Access Compliance Report

Public Rights-of-Way

Intersection ID: 10867	Main Street: E_35TH_ST	Cross Street: THE_PLAZA	Location: E
ADA ID: A2087C37B2AD	Ramp Type: PerpDiag	Initial Pass/Fail: Fail	Overall Compliance: No
			Severity Score: 21.25

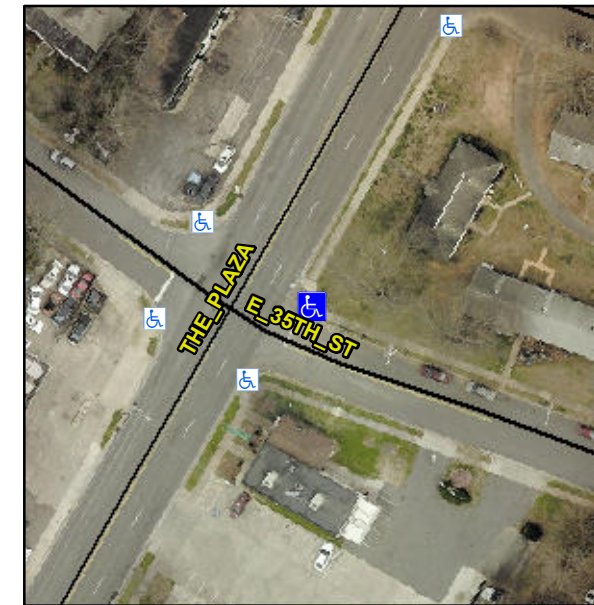
Not Found, R304.5.1, R304.2.2

Compliance	Description	Data	Compliance	Description	Data
N/A	Ramp Length (in)	65.0	No	Ramp Slope (%)	8.6
No	Ramp Width (in)	47.5	Yes	Ramp XSlope (%)	1.2
N/A	Flare Type LT	N/A	N/A	Flare Type RT	N/A
N/A	Flare Slope LT (%)	N/A	N/A	Flare Slope RT (%)	N/A
N/A	Flare Traversable LT?	N/A	N/A	Flare Traversable RT?	N/A
N/A	Landing Length (in)	N/A	N/A	DWS Provided?	N/A
N/A	Landing Width (in)	N/A	N/A	DWS Contrast?	N/A
N/A	Landing Slope (%)	N/A	N/A	DWS Length (in)	N/A
N/A	Landing X Slope (%)	N/A	N/A	DWS Full Width?	N/A
N/A	Landing Curb? (Y/N)	N/A	N/A	DWS Offset (in)	N/A
N/A	Shared Landing?	N/A			
N/A	Gutter Ponding?	N/A	N/A	Gutter Slope (%)	N/A
N/A	Gutter Lip Ht (in)	N/A	N/A	Gutter X Slope (%)	N/A
N/A	Painted X Walk1?	No	N/A	Painted X Walk2?	No
	X Walk 1 Direction	To NW		X Walk 2 Direction	To SW
N/A	X Walk 1 Width (in)	N/A	N/A	X Walk 2 Width (in)	N/A
	X Walk 1 Slope (%)	4.9		X Walk 2 Slope (%)	0.0
	X Walk 1 X Slope (%)	1.0		X Walk 2 X Slope (%)	0.0

Remove & Replace Curb Ramp With Two New Directional Ramps or Equivalent.
